**HOWARD COUNTY
PERMIT APPLICATION**

000/51213 KN

Re: Site Inspection/ B00151213
3451 Blackberry Lane

SITE PLAN

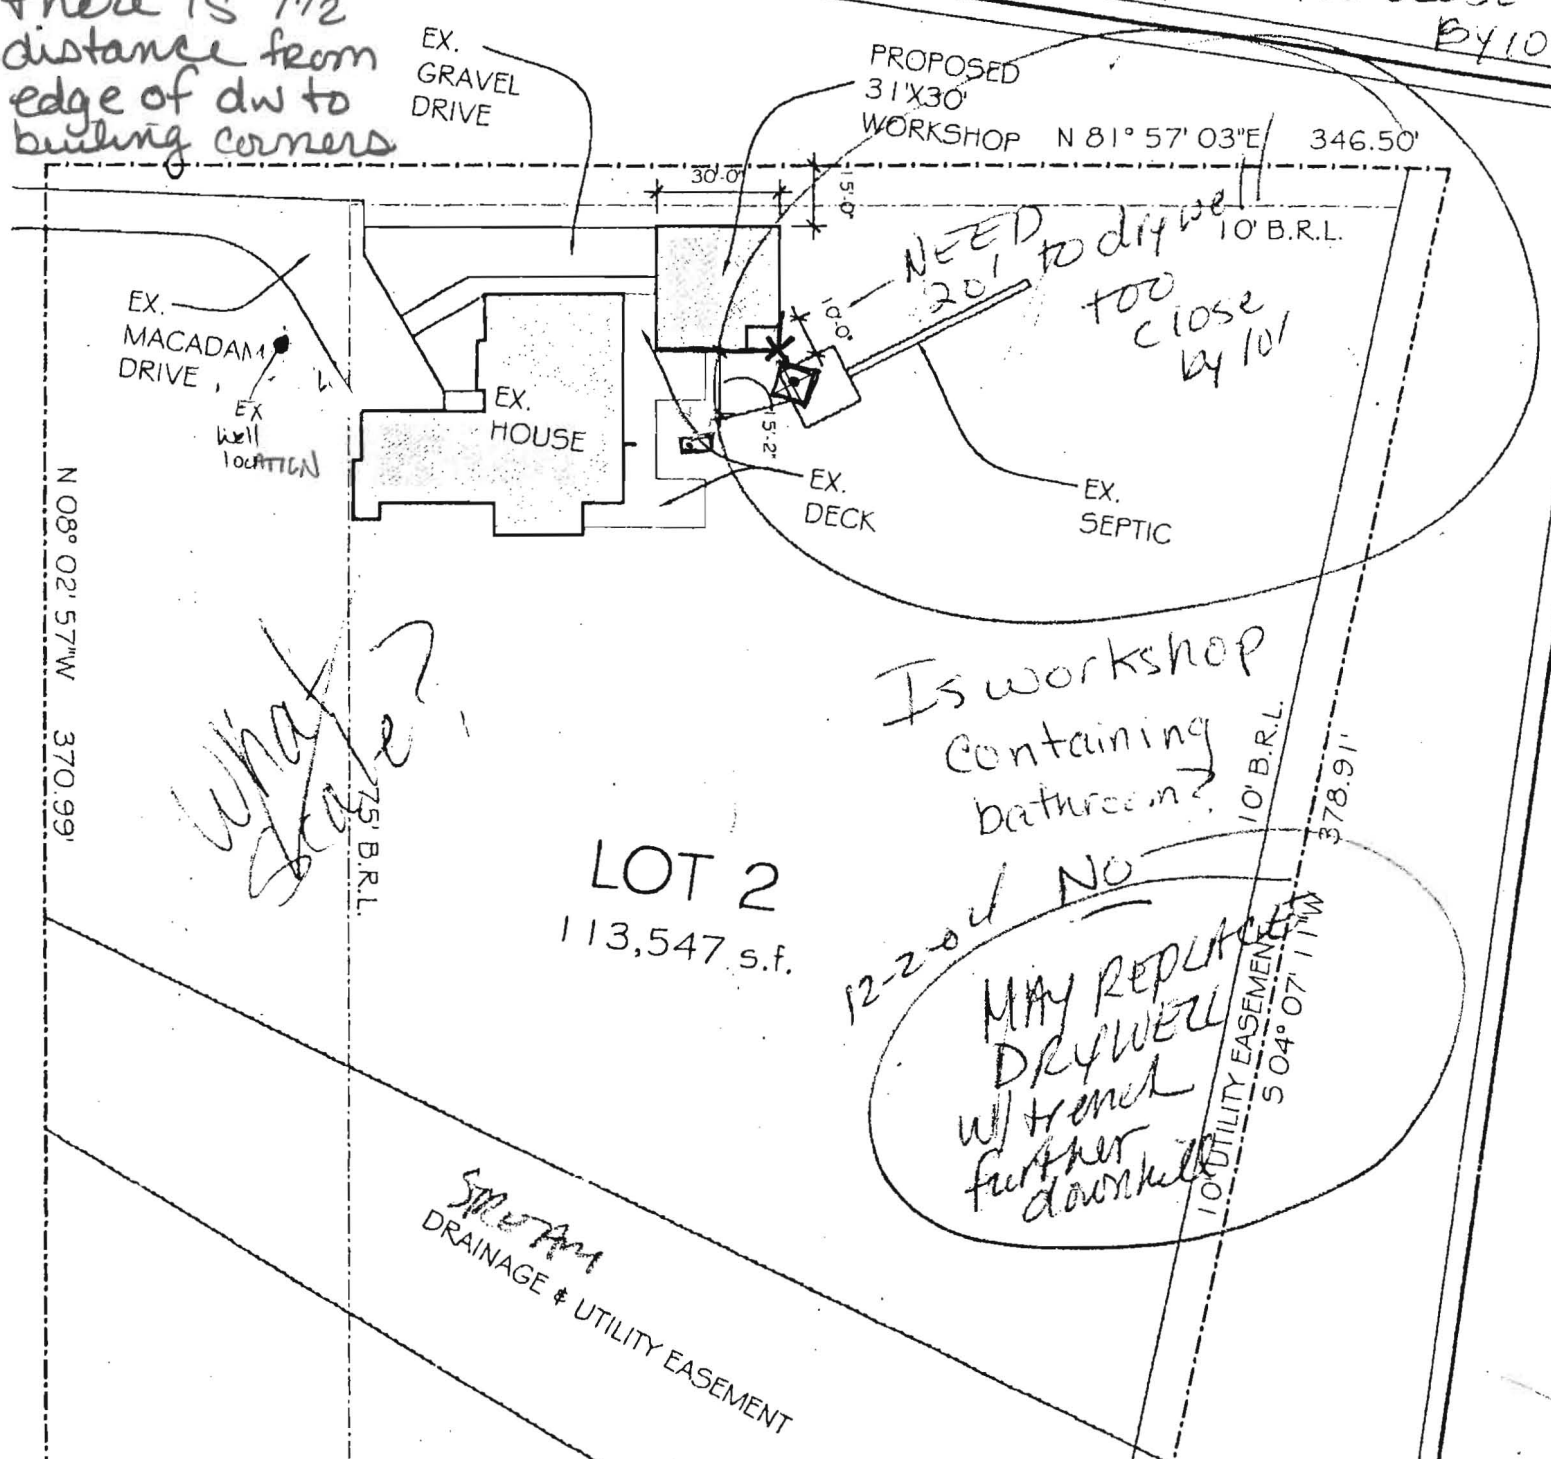
If this is the case, then submit plan to scale for signature

Workshop width altered? Is that why showing radius around dry well?

1/10/05 Addition must be 10' from edge of drywell (its perimeter)
 Either alter footprint of workshop to meet the requirement or replace drywell for permit approval

12-20-04 SINCE PROPOSED STRUCTURE'S STAKES NOT THERE, I measured to "X" below. Actual footprint in another 5'

EX DRYWELL DIMENSIONS 15x15, From "X" to

C/D IS 10' EXACTLY

STILL TOO CLOSE BY 10'

ESSENTIALLY there IS 7 1/2' distance from edge of dw to building corners

what stake?

Is workshop containing bathroom?

12-20-04 NO MAY REPLACE DRYWELL w/ trench further downhill

SITE PLAN

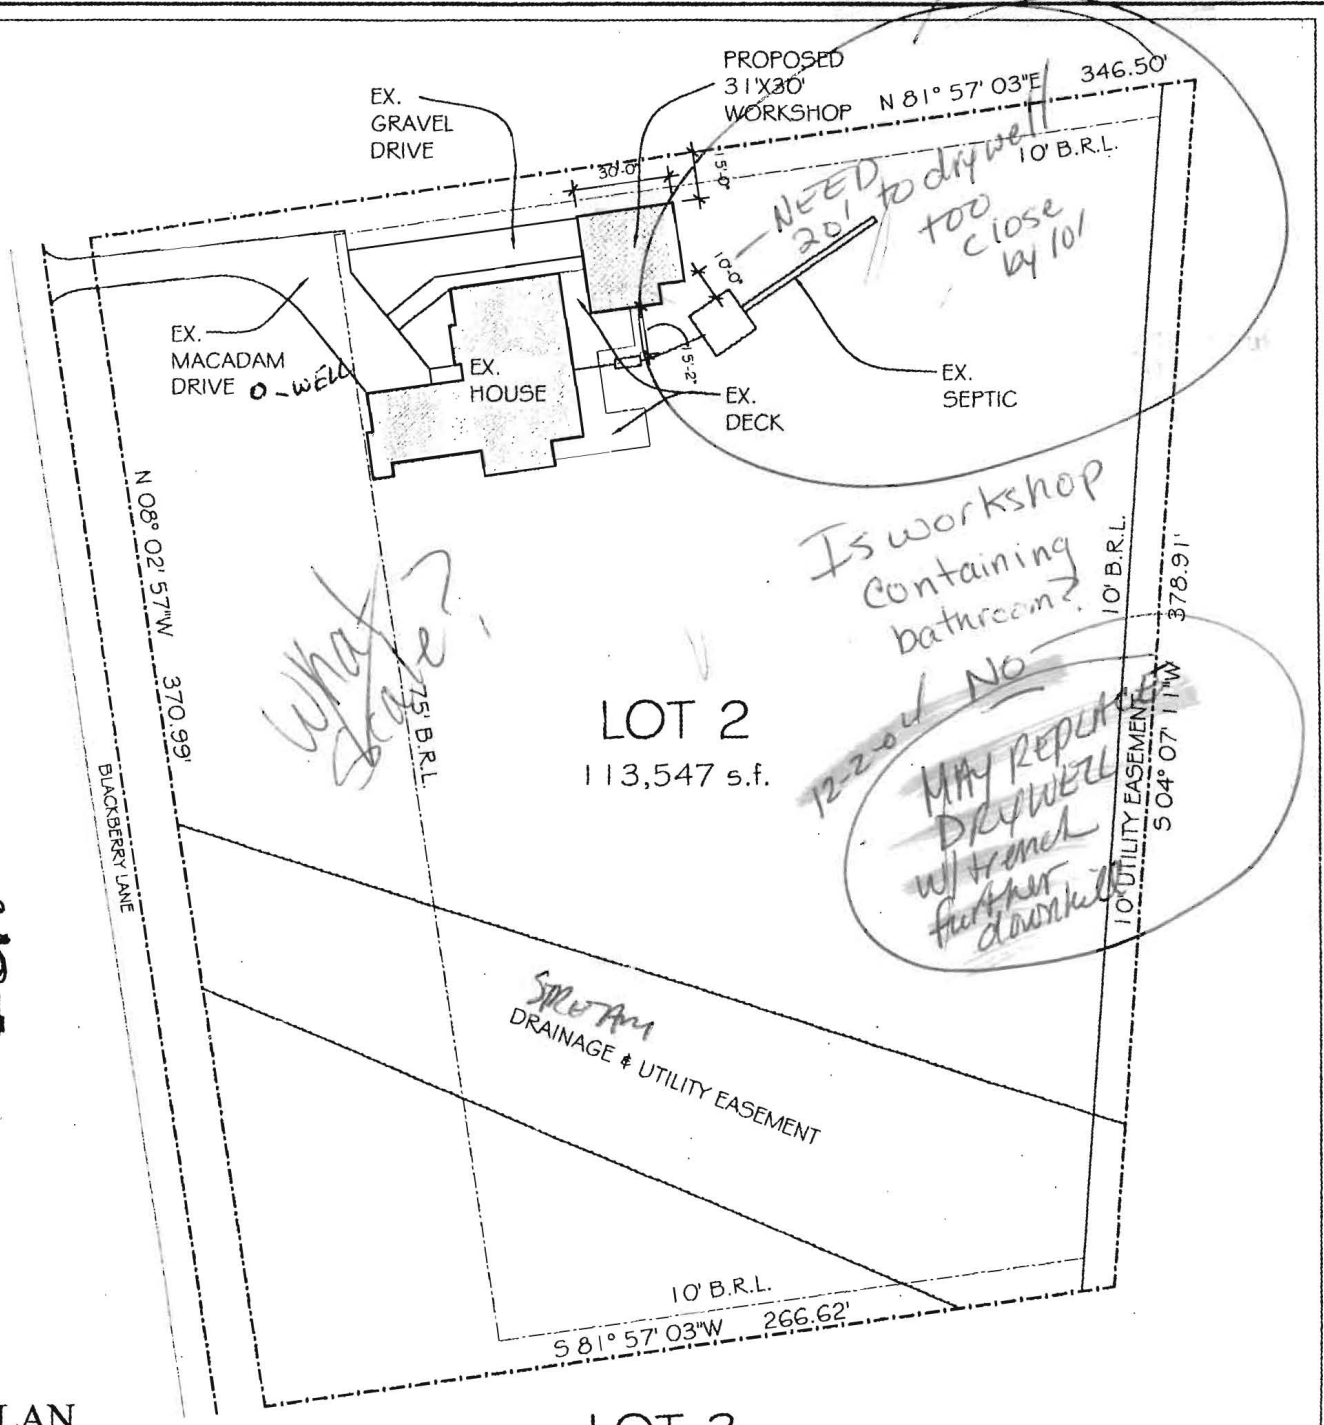
S.T. to jacuzzi deck
edge 23'
• C/O to
S.T. 22' 1/4" = 1 foot

STILL
TOO CLOSE
BY 10'
